TECHNICAL EVALUATION REPORT  
KEWAUNEE NUCLEAR POWER PLANT  
STATION BLACKOUT EVALUATION

TAC No. 68558

Final  
September 28, 1990

U.S. Nuclear Regulatory Commission  
Washington, D.C. 20555

FIGURE 1

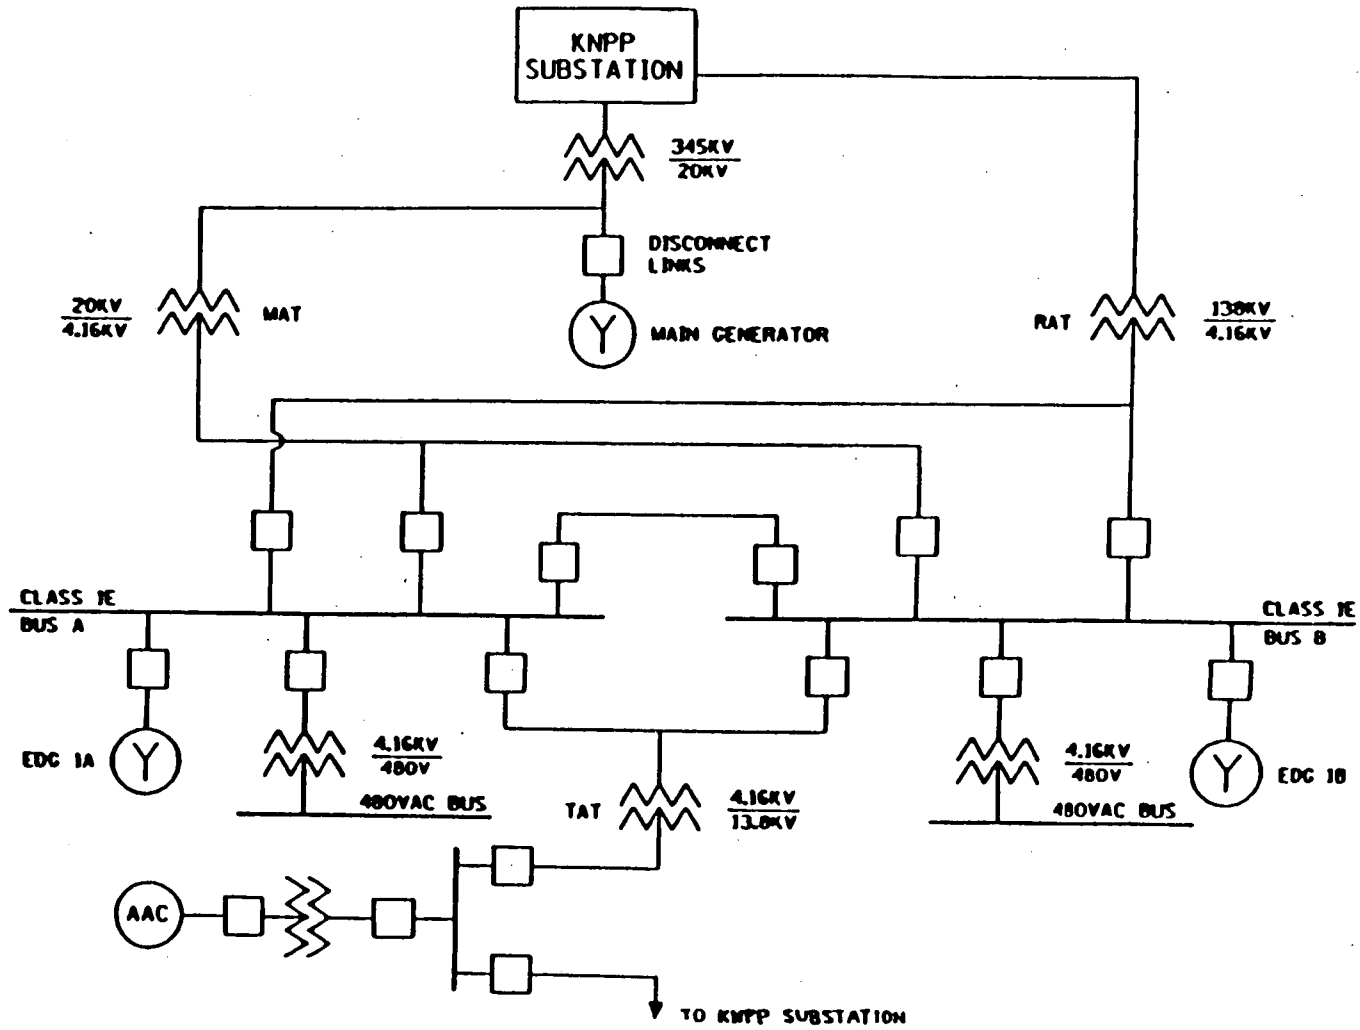
The licensee stated that the independence of the plant offsite power system (Figure 1) grouping is "1 1/2." A review of KNPP USAR indicates that:

Based on the above and the criteria stated in Table 5 of RG 1.155 the plant independence of offsite power system group is classified as "I2."

The licensee proposes to install a 2000 kW non-class 1E diesel generator (DG) as an AAC power source, see Figure 1 (13). The licensee stated that the AAC power source will be available within 10 minutes of the onset of an SBO event. This power source will have sufficient capacity and capability to operate systems necessary for coping with an SBO for the required duration of four hours.

Although the licensee stated that prior to declaring the system operational, an initial test will be performed to demonstrate the capability of powering the required shutdown equipment, it should be emphasized that this test should demonstrate adequate voltage and frequency regulation under the most severe realistic transient loading condition. Also, this test must demonstrate that the proposed AAC power source is capable of powering the required shutdown equipment within 10 minutes of the onset of an SBO event.

The licensee needs to establish a maintenance and surveillance testing program for the AAC power source in order to provide assurance of high DG reliability and compliance to NUMARC 87-00, Appendix B, Paragraphs B.10, B.11 and B.13.

The licensee needs to make a direct commitment to meet the criteria specified in Appendix B of NUMARC 87-00. As part of this commitment, the licensee needs to establish a maintenance and surveillance testing program for the AAC power source in order to provide assurance of maintaining high reliability consistent with the criteria specified in Paragraphs B.10, B.11 and B.13.
